3. Levan-Sterling Subdivision

KPB File 2022-125

ITEM 3 - LEVAN-STERLING SUBDIVISION

STAFF REPORT

LEVAN-STERLING SUBDIVISION

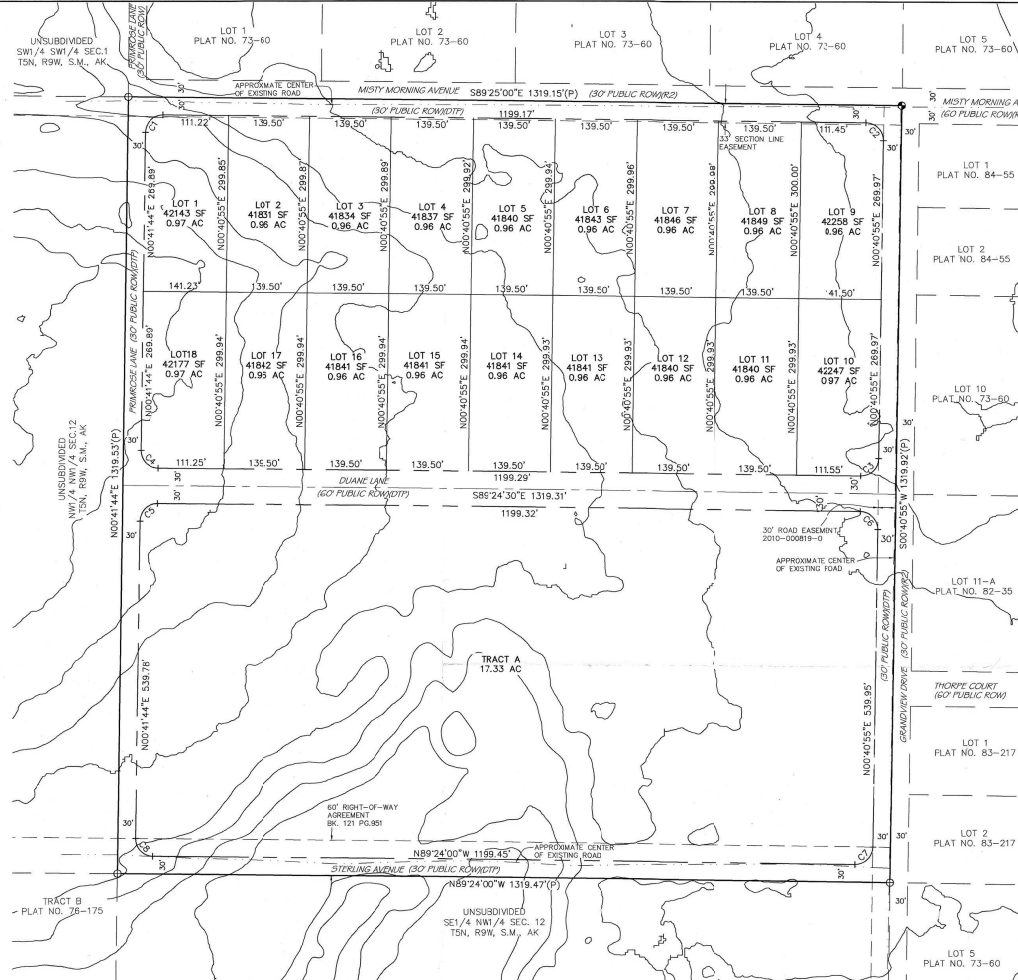
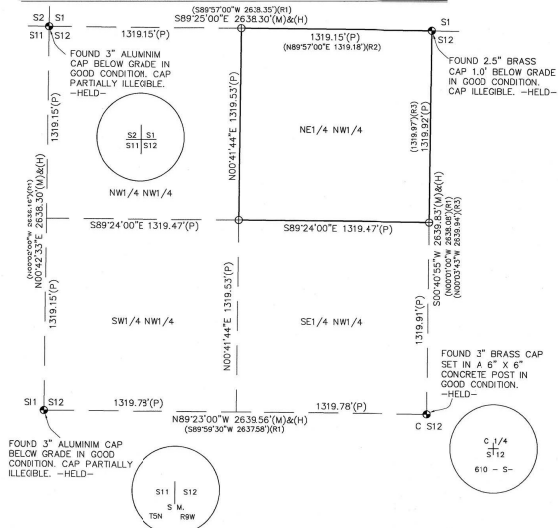
The preliminary plat shows a dedication along the north of a 30 foot right-of-way for Misty Morning Avenue that will be atop a 33-foot section line easement. The plat indicates that the abutting dedication and the dedication to the east is 30 feet on each side, per Grandview Subdivision, Plat KN 73-60 the dedications are 33 feet in width. **Staff recommends the depiction and labels be adjusted.**

Along the eastern boundary the plat shows a 30-foot right-of-way dedication for Grandview Drive to bring the right-of-way into compliance for width. Grandview Drive is constructed and maintained by the borough. This dedication is occurring atop a public easement granted by recorded document. **Staff recommends the easement label include "public" or a plat note be added that includes the details and description of location and states it is now within the dedicated portion of Grandview Drive.**

On the south of the plat a 30 foot wide dedication is proposed for Sterling Avenue. A new name will be required to be approved by the Addressing Officer as well as confirming all other names proposed on the plat. The plat shows along the proposed dedication the approximate center of an existing travelway. There is also a 60 foot wide right-of-way created by recorded document. Upon reviewing the document it needs to be clarified if that easement is public or private. ENSTAR reviewed the plat and noted there is a transmission line within the 60 foot right-of-way agreement and any development within the dedication should be coordinated with Alaska Pipeline Company (APC). The question remains if the depicted existing road is truly a road or the cleared area used by APC or the location of the pipeline. Upon staff's review of the proposed dedication, the existence of the 60 foot wide easement, and ENSTAR's comments, **staff recommends the transmission line be located, the surveyor work with APC and based on the line's location determine the best dedications along the southern boundary. Update the label to indicate if the right-of-way agreement is public or private or add a plat note with the details, and do one of the following or provide alternative that is agreeable by all parties.**

Site Investigation: The preliminary plat does not contain any steep areas or low wet lands. The land appears to be vacant with no neighboring encroachment issues. As discussed under the legal access portion of the staff report, the rights-of-way along the north and west are constructed and maintained by the borough. **Staff recommends the terrain be removed from the final plat.**

New utility easement as identified in note 2 as “the front 10’ of the 20’ Building Setback and the entire 20’ Building Setback within 5’ of side lot lines”. A typical building setback detail is provided that shows the setback and utility easements as described within the plat note. **Staff recommends** the plat note include “granted by this plat”.

*In references, check the spelling of subdivisions.
The existing road depictions may be removed.*

Staff recommendation: The legal description needs corrected to NE1/4 NW1/4

- C. The location, width, and name of existing or platted streets and public ways, railroad rights-of-way, and other important features such as section lines or political subdivisions or municipal corporation boundaries abutting the subdivision;
Staff recommendation: *North half of Misty Morning Avenue is 33' change on drawing*

- D. A vicinity map, drawn to scale showing location of proposed subdivision, north arrow if different from plat orientation, township and range, section lines, roads, political boundaries, and prominent natural and manmade features, such as shorelines or streams;
Staff recommendation: *The Misty Morning Avenue label appears along the right-of-way known as Robinson Loop Road. Add "Loop Road" to Scout Lake Loop Road Label. The Funny River label in section 24 should have "Road" added. If this is to reference the river the line depiction should be added to make it clear.*

- F. The location, width and name of existing and platted streets and public ways, railroad rights-of-way, easements, and travel ways existing and proposed, within the subdivision;
Staff recommendation: *Sterling is not an allowable street name. Continue Entrada Drive or receive an approved name from the addressing officer. Duane Lane should be Avenue and approval will be required from the Addressing Officer.*

- G. The status of adjacent lands within 100 feet of the proposed subdivision boundary or the land status across from any dedicated rights-of-way that adjoin the propose subdivision boundary, including names of subdivisions, lot lines, block numbers, lot numbers, rights-of-way; or an indication that the adjacent land is not subdivided;
Staff recommendation: *Lot to southeast needs to be corrected from Lot 5 to Lot 13.*

Staff recommendation: *Update the dedication of Sterling Avenue as determined by field survey.*

- Update plat note 5 to include KPB Code reference. "Roads must meet the design and construction standards established by the borough in order to be considered for certification and inclusion in the road maintenance program (KPB 14.06)."
- Remove "nominal five acres" from the wastewater note.

Staff recommendation: *Per the Certificate to Plat the ownership is under Mr. Levan's name only. Correct the ownership statement to be in the singular and remove Alice Levan from the statement. Comply with 20.60.190.*
